FLORIDA POWER & LIGHT COMPANY

Re: Turkey Point Units 3 & 4
Docket Nos. 50-250 & 50-251
Fire Protection

The attached information is applicable to asterisked items 3.1.2, 3.1.6, 3.1.7, and 3.1.15 in the Safety Evaluation for Amendments 45 and 37 to Operating License DPR-31 and DPR-41, respectively. Information on items 3.1.1(4) and 3.1.1(5) is being developed and will be submitted by approximately December 15, 1979.

FIRE WATER SUPPLY (3.1.2)

ATTACHMENT 2
DETAIL B
FIG. 6

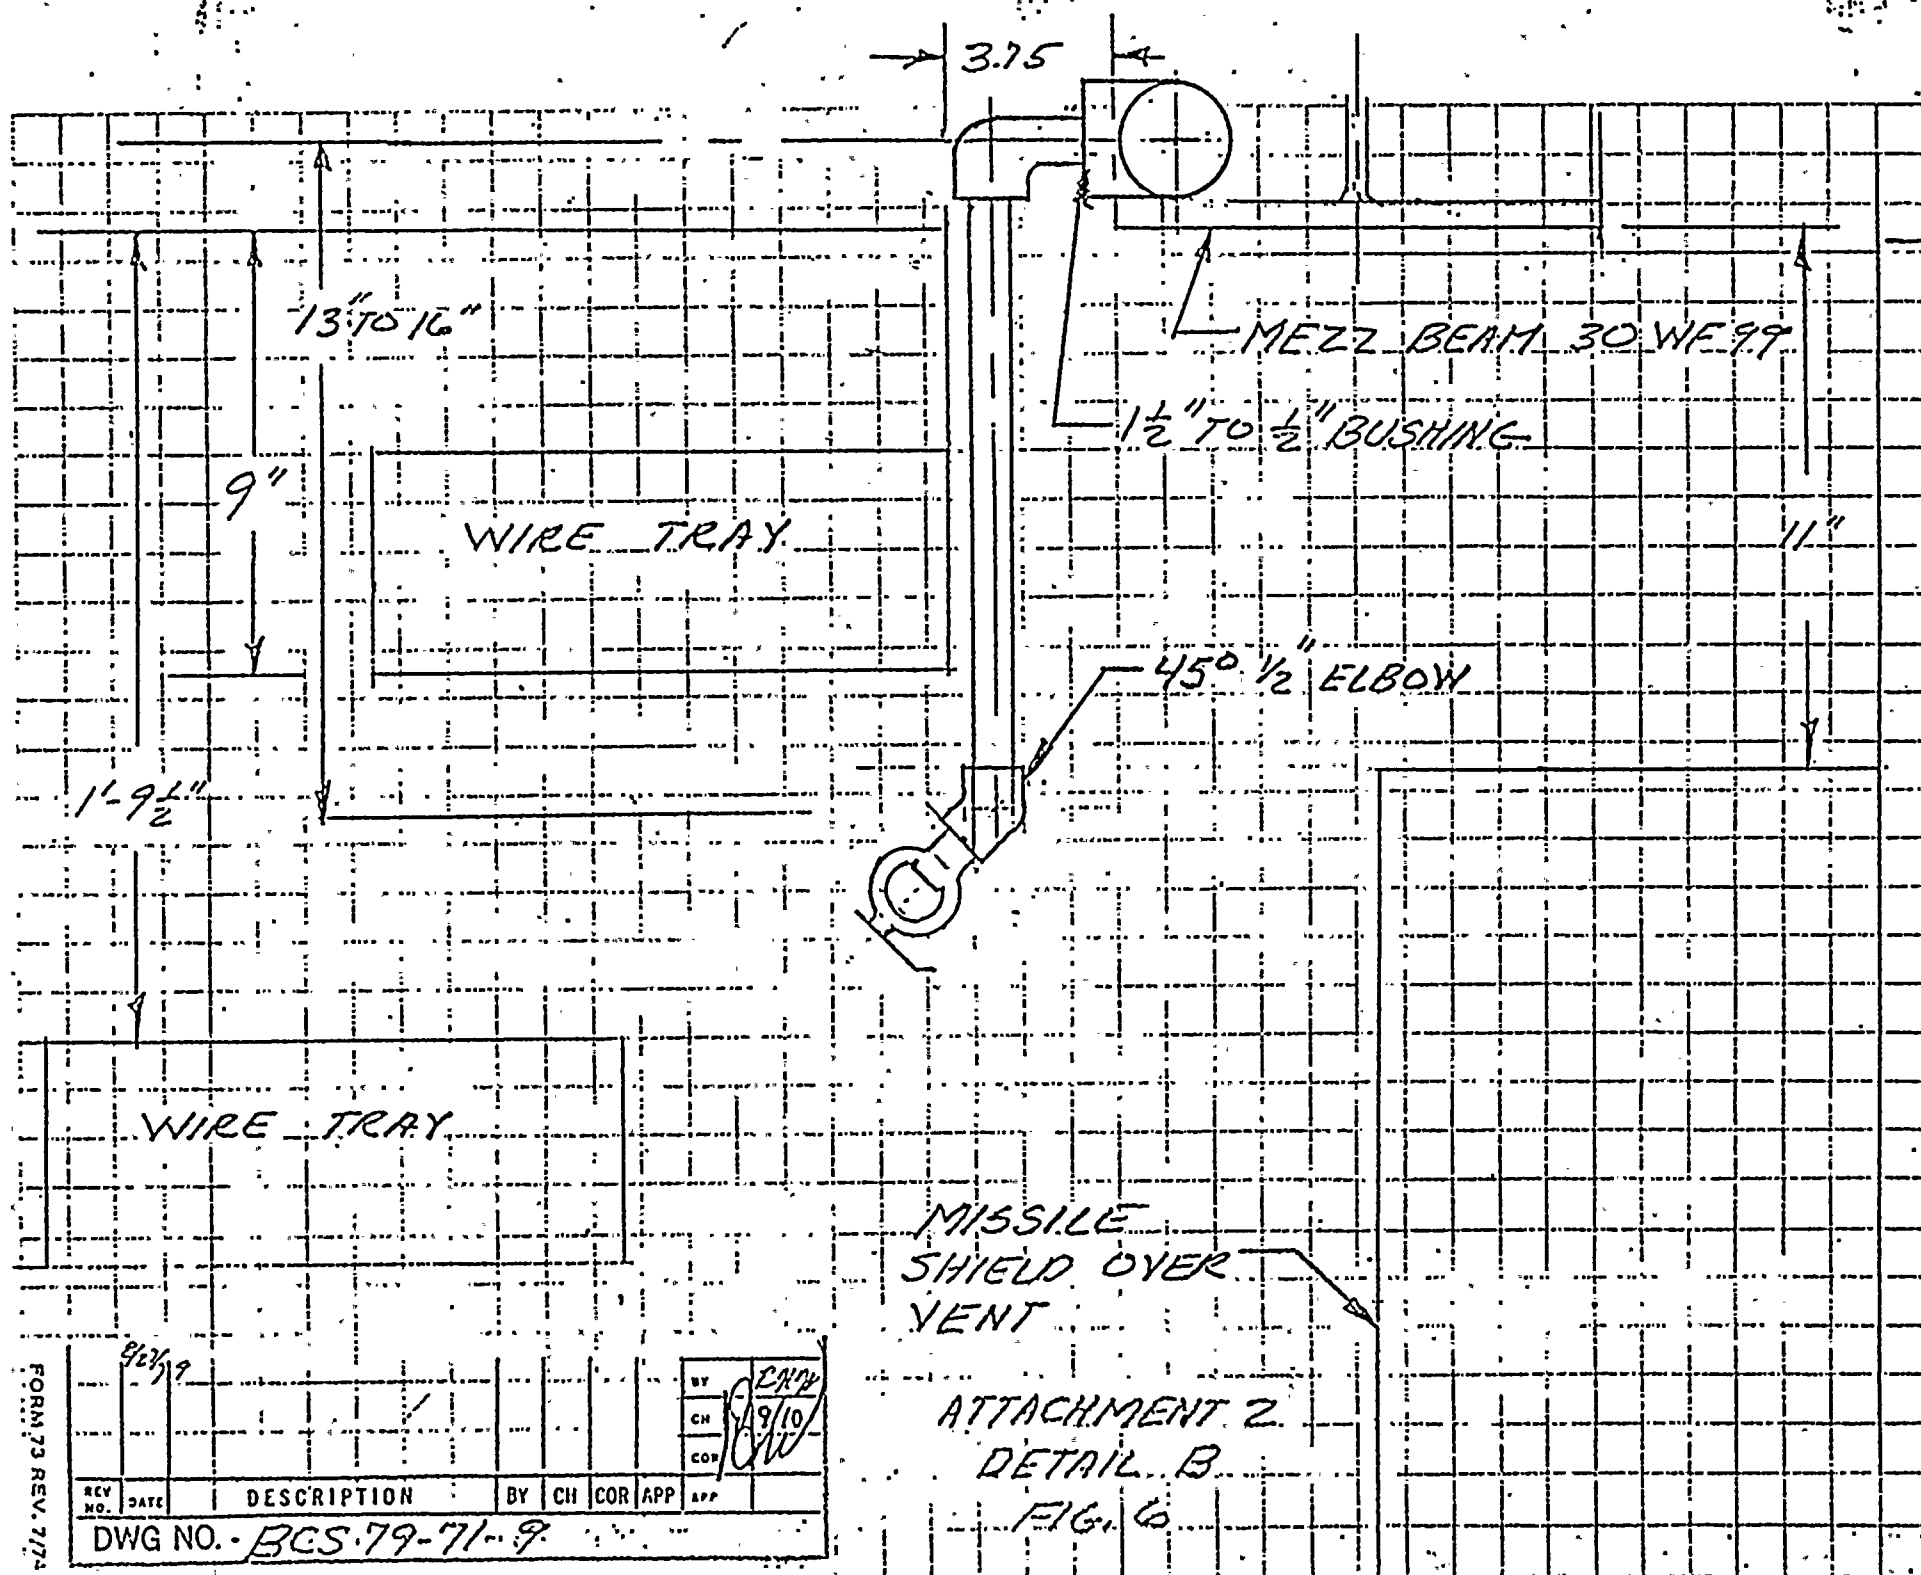
MISSILE
SHIELD OVER
VENT

ATTACHMENT 2
 VIEW A-A UNIT #4
 FIG. 2

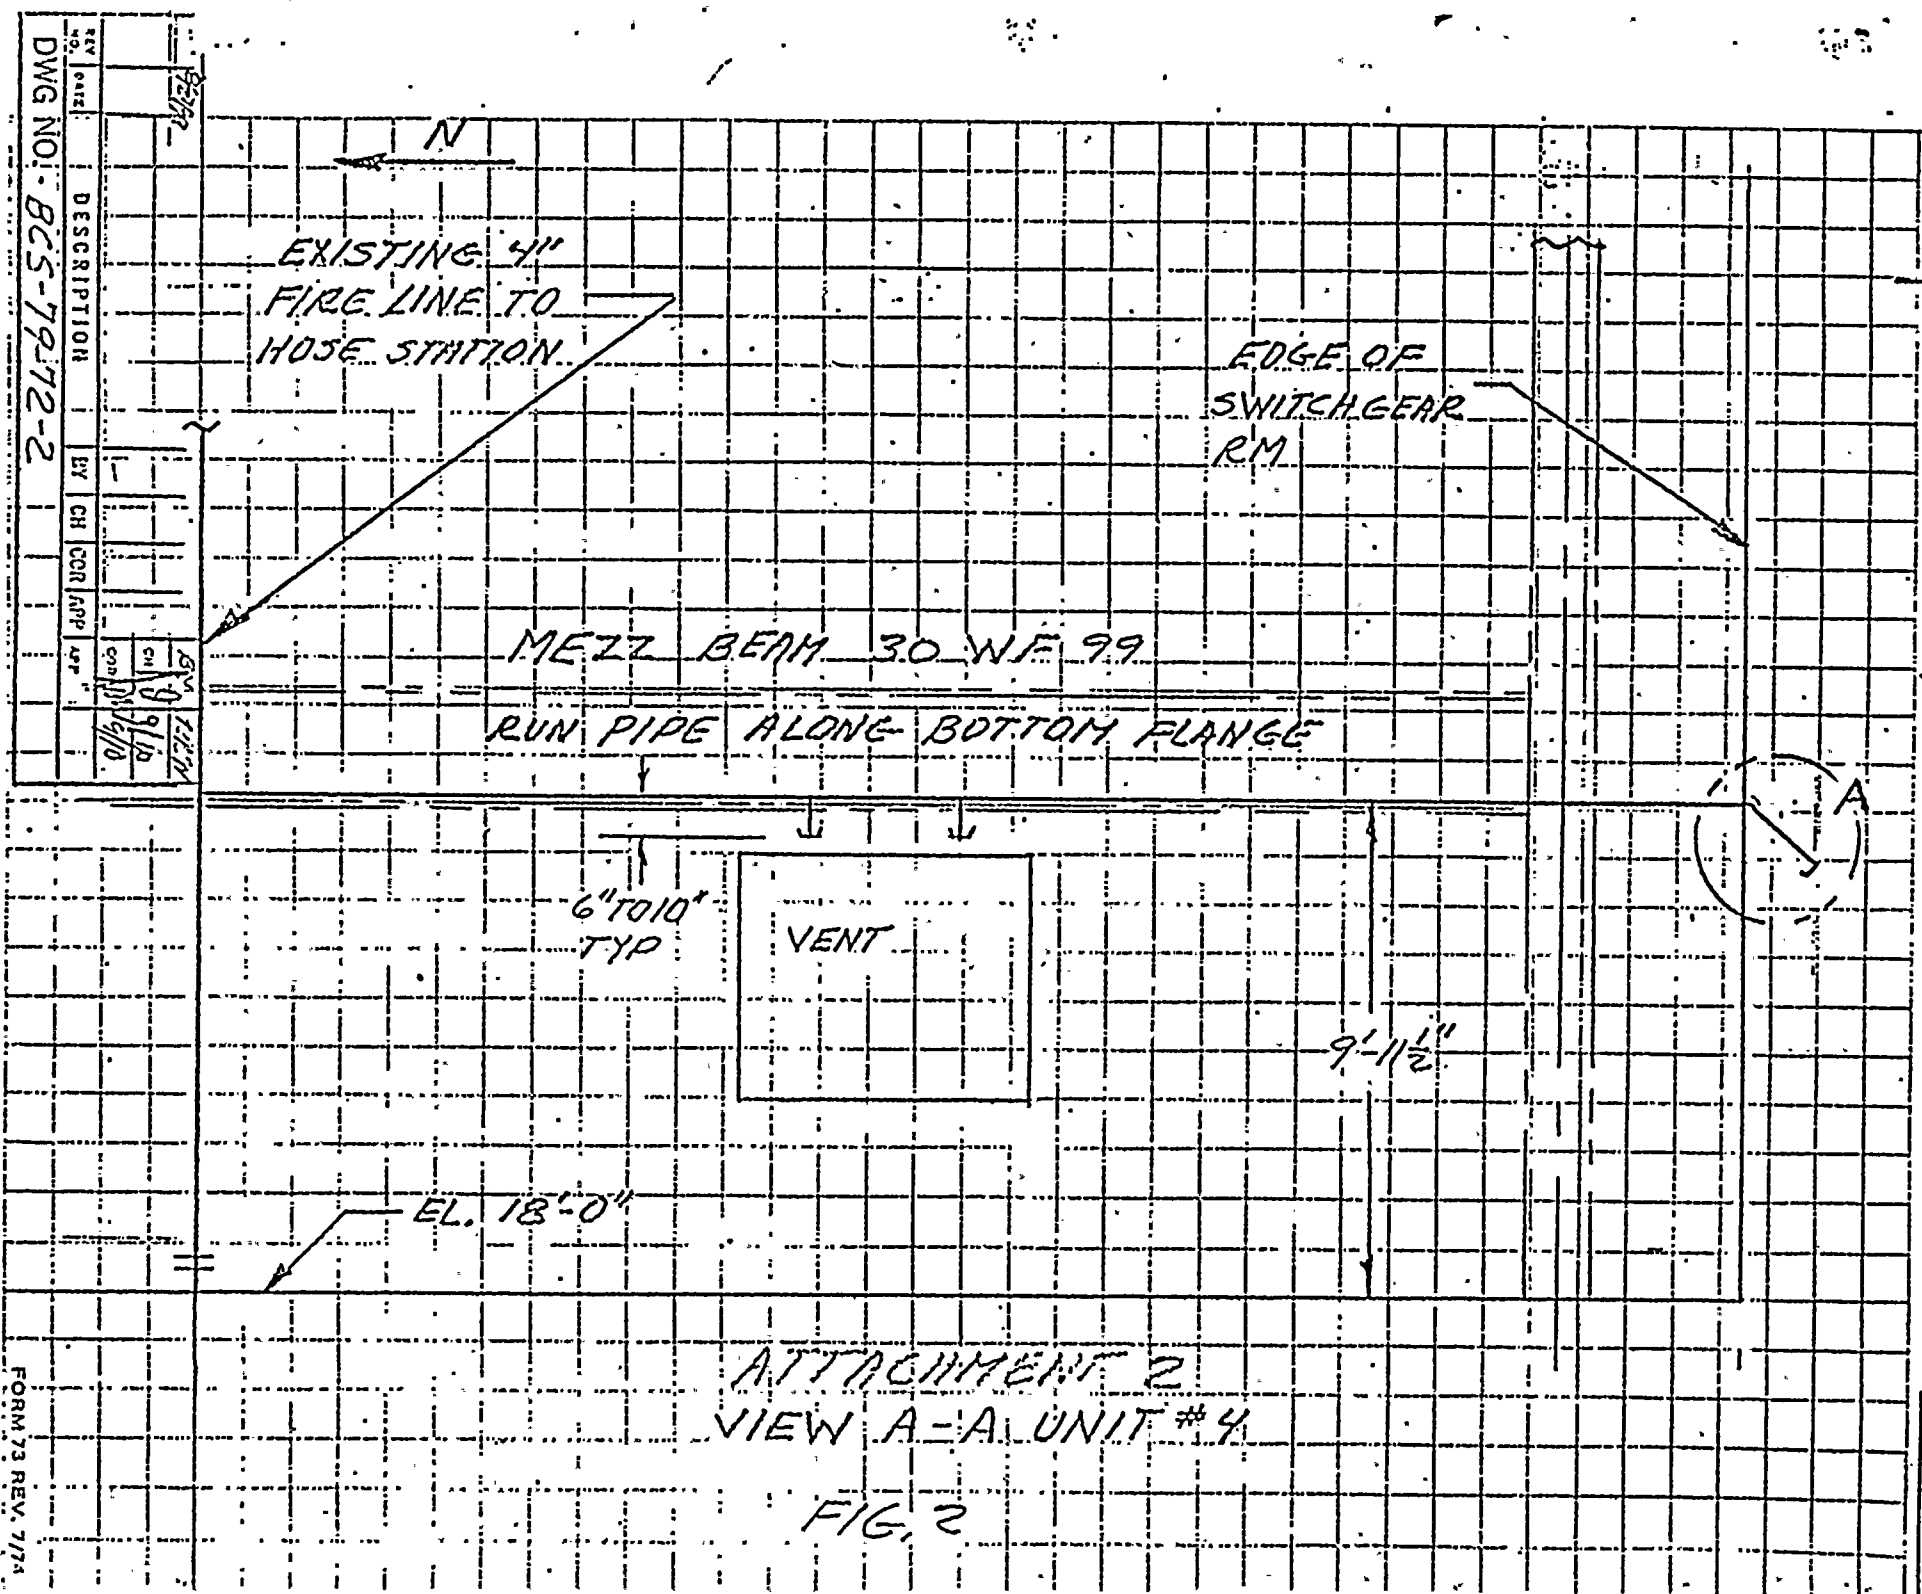
ADD A WATER CURTAIN FOR THE DOOR AND VENT OPENINGS ON THE WEST SIDE OF THE SWITCHGEAR ROOM. SEE ATTACHMENT 2.
- c) Purpose/Reason for Request (If this PC/M constitutes a change in the plant as described in the FSAR, attach written safety evaluation).

WELD THREADED LET TO
EXISTING 4" LINE FROM
HOSE STATION ON TURBINE
DECK

INSTALLATION SKETCHES

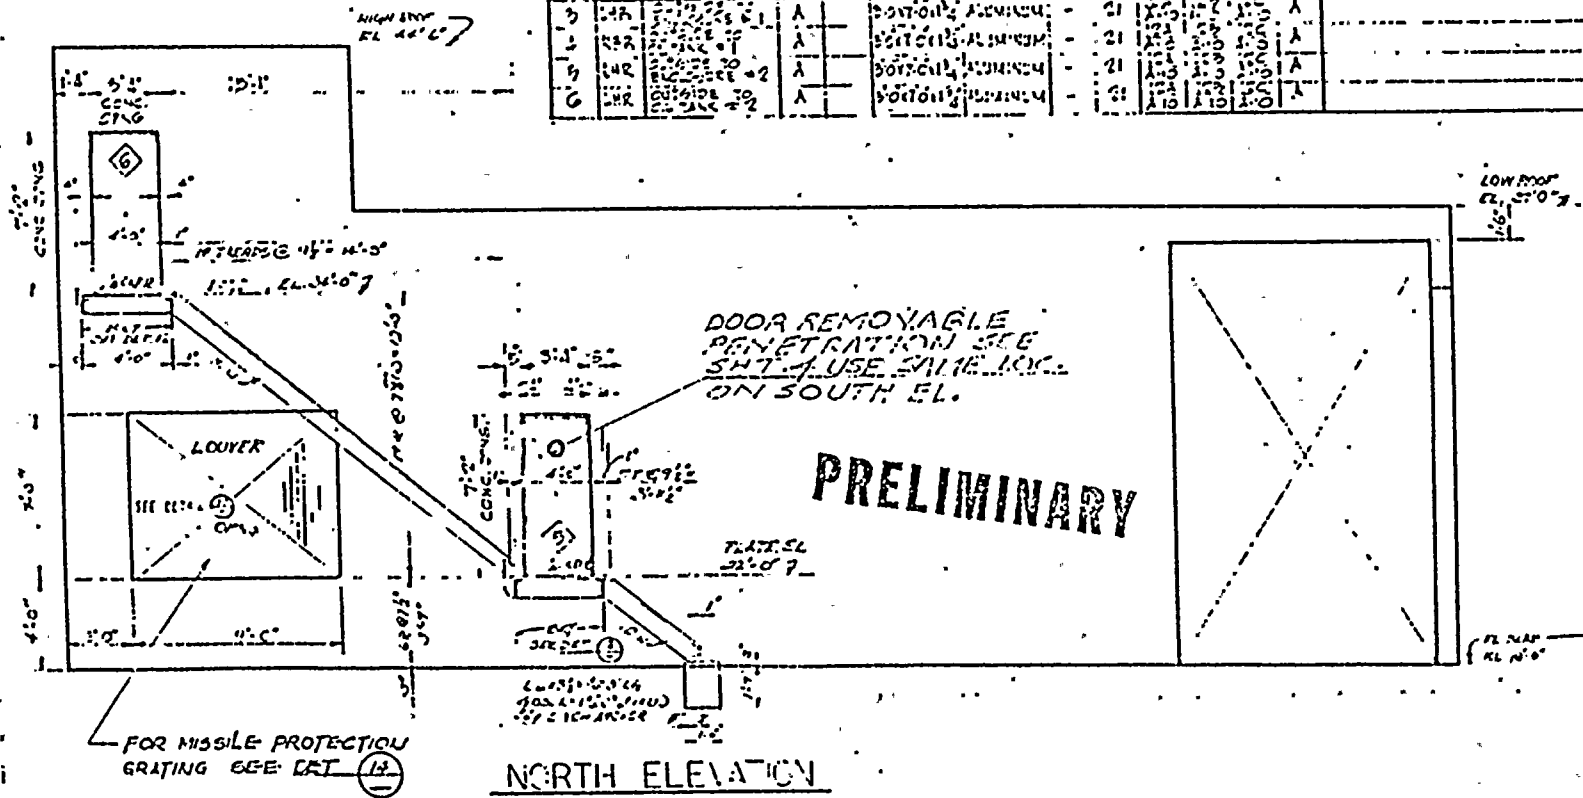
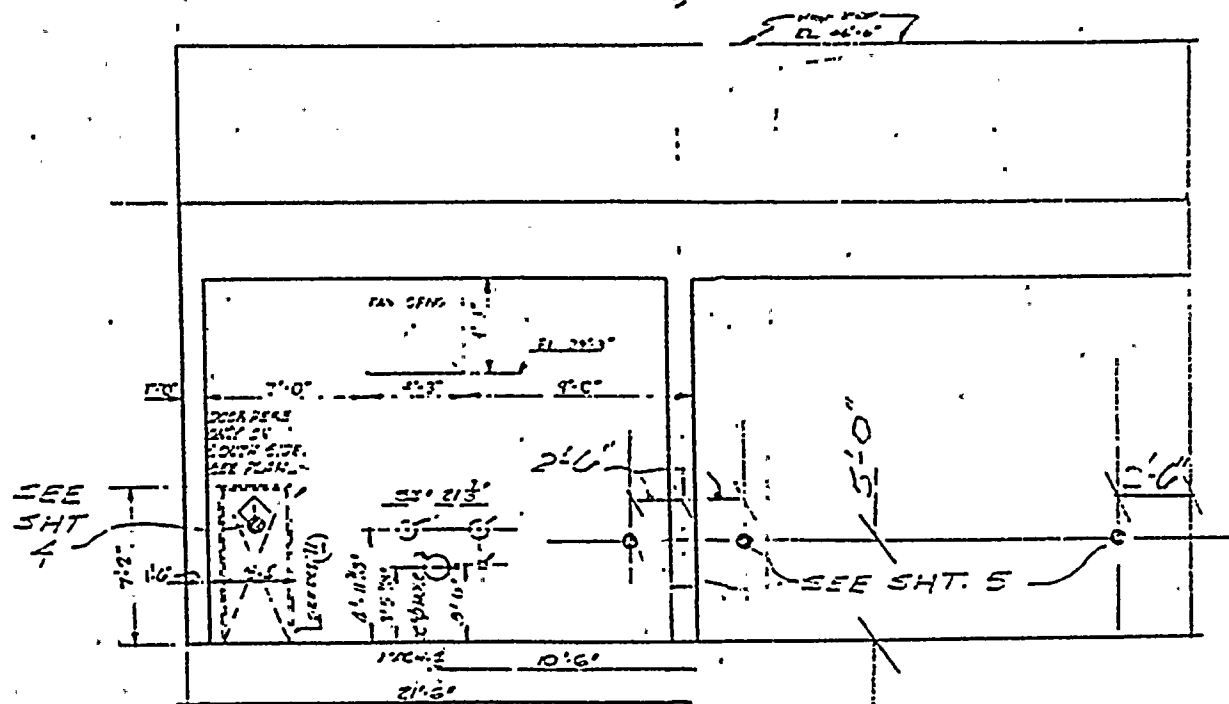
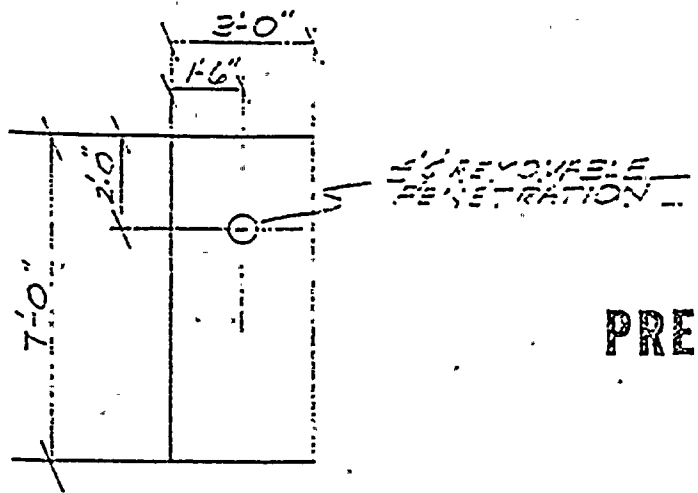
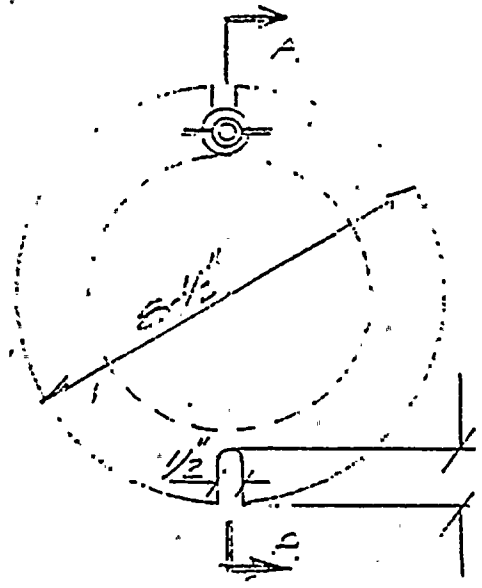
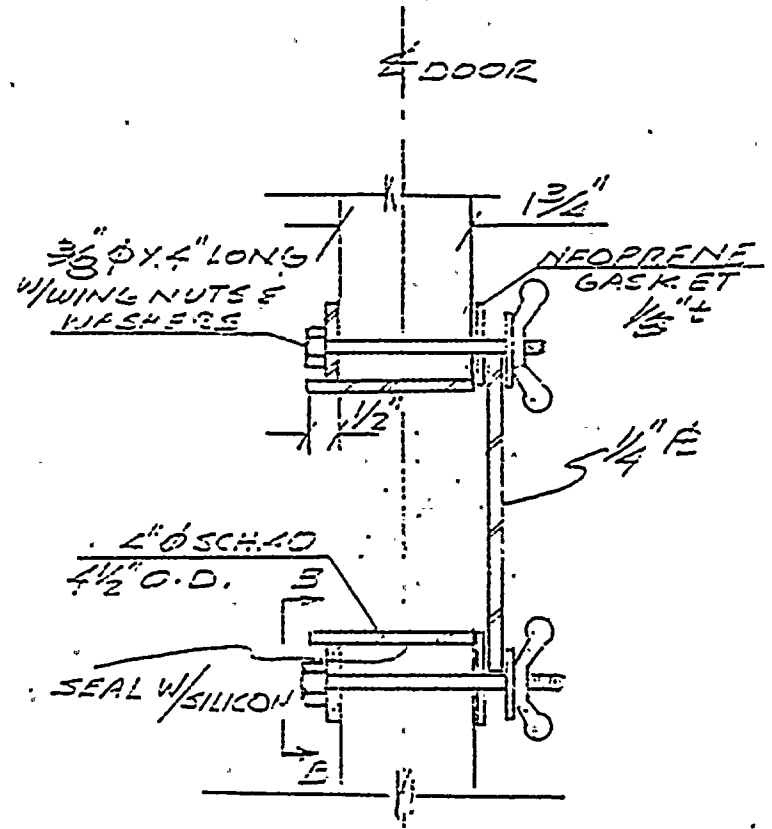
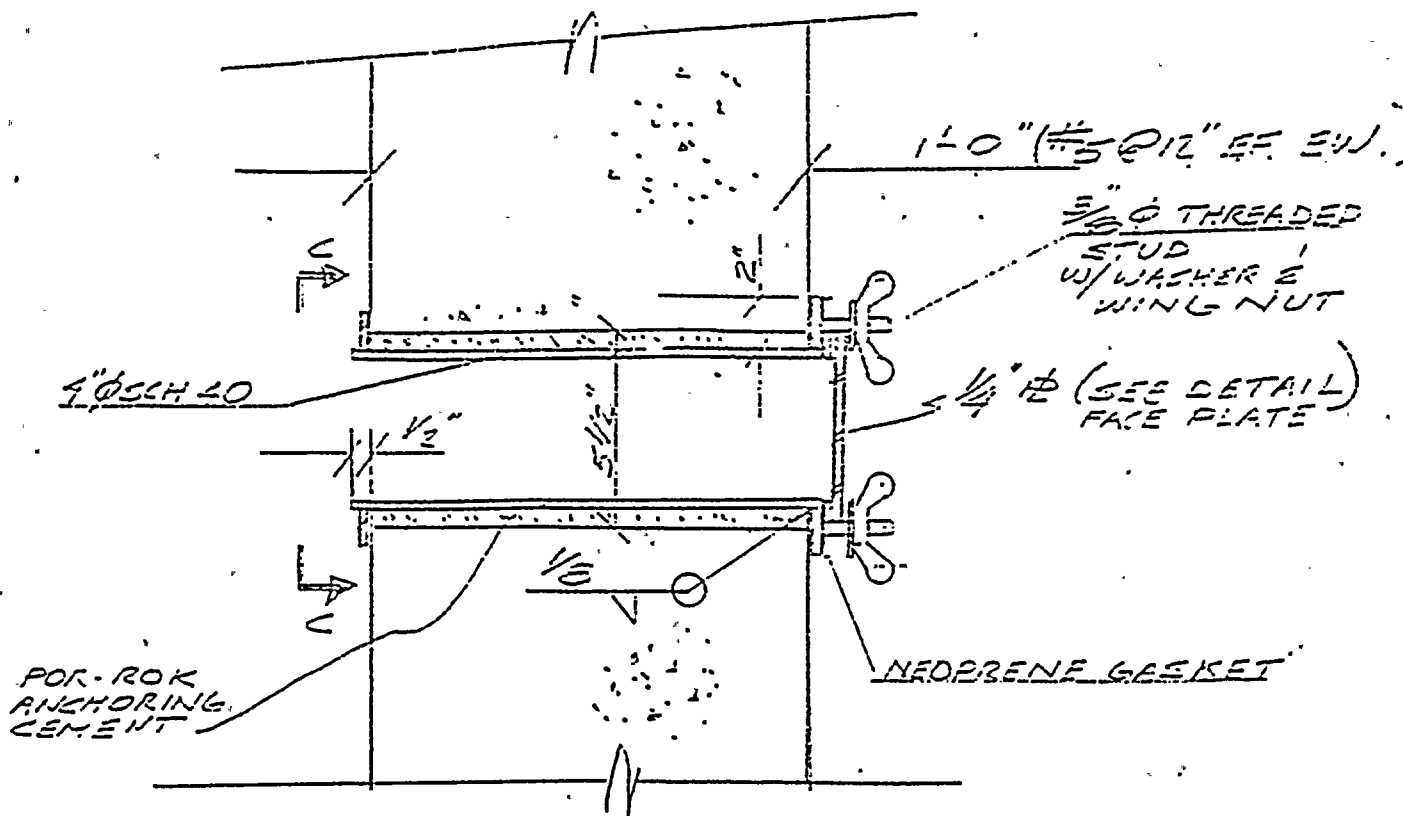
This PC/M includes the sketches, specifications, and procedures for the installation of 3-4" ϕ penetrations through the Diesel Generator Room exterior walls and doors. The penetrations have been designed with fast release covers to maintain a structural seal when not used and to provide a quick access to the interior of the Diesel Generator Room when needed.

- B.1. Cut a 4 9/16" ϕ hole through the specified doors at the locations as shown on the Installation sketches.
- B.2. Weld pipe ears to the schedule 40 penetration pipe as shown.
- B.3. Slide penetration pipe into the applicable door starting from the interior face of the door.
- B.4. Drill 7/16" ϕ holes through the pipe ears and the door as shown.
- B.5. Seal the specified seams with Silicon Sealer.
- B.6. Install the 3/8" ϕ bolts as shown and tack weld bolt head to the pipe ear.
- B.7. Place the 1/8" thick neoprene gasket.
- B.8. Lubricate the threaded ends of the bolts with a light grease and attach the face plate as shown. Wing nuts shall be tightened finger tight.

- C.1. Core drill 5 1/2" ϕ hole through the specified walls at the locations as shown on the Installation sketches. Prior to drilling, a metal detector and/or stud finder shall be used to locate rebar on the interior and exterior faces of the specified wall. As a guide, reinforcement in the wall is shown on the Installation sketches. The rebar shall be mapped on each face of the wall using chalk or a marker which can be readily seen and removed. The penetration may be relocated plus or minus one foot in any direction in order to avoid cutting rebar during the process of core drilling. In the event that core drilling results in rebar being cut through, the

- C.2. Weld the ring plate to the schedule 40 penetration pipe as shown. Weld the 3/8" ϕ studs to the ring plate as shown.
- C.3. Place penetration pipe into the applicable wall and center the pipe in the hole with wedges. Weld the pipe ears to the penetration pipe as shown. Grout the annular space between the outside of the penetration pipe and the wall with Por Rok Anchoring Cement.
- C.4. Place the 1/8" thick neoprene gasket.
- C.5. Lubricate the threaded ends of the 3/8" ϕ studs with a light grease and attach the face plate as shown. Wing nuts shall be tightened finger tight.
